ACE-99-05

The purpose of this Special Airworthiness Information Bulletin (SAIB) is to advise registered owners of certain Cessna twin engine models of the need to determine if there is adequate alternate crankcase breather provisions.

This SAIB is being sent to registered owners of: Cessna 300 and 400 Series Model airplanes except for the 303, 336 and 337 series airplanes.

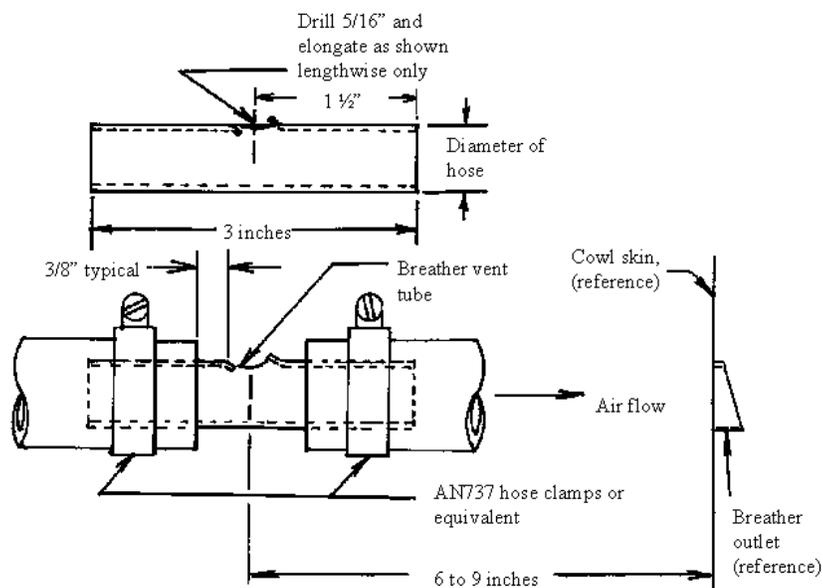
The FAA has not mandated this modification but is strongly recommending that owners/operators of the affected airplanes examine the crankcase venting provisions installed on their airplanes for the existence of adequate alternate

venting provisions, which should be a slit or hole (at least approximately one inch by .25 inches) in the breather line within a minimum of six inches inside the cowling.

If these provisions do not exist, it is recommended that alternate crankcase venting provisions be incorporated per the below figure.
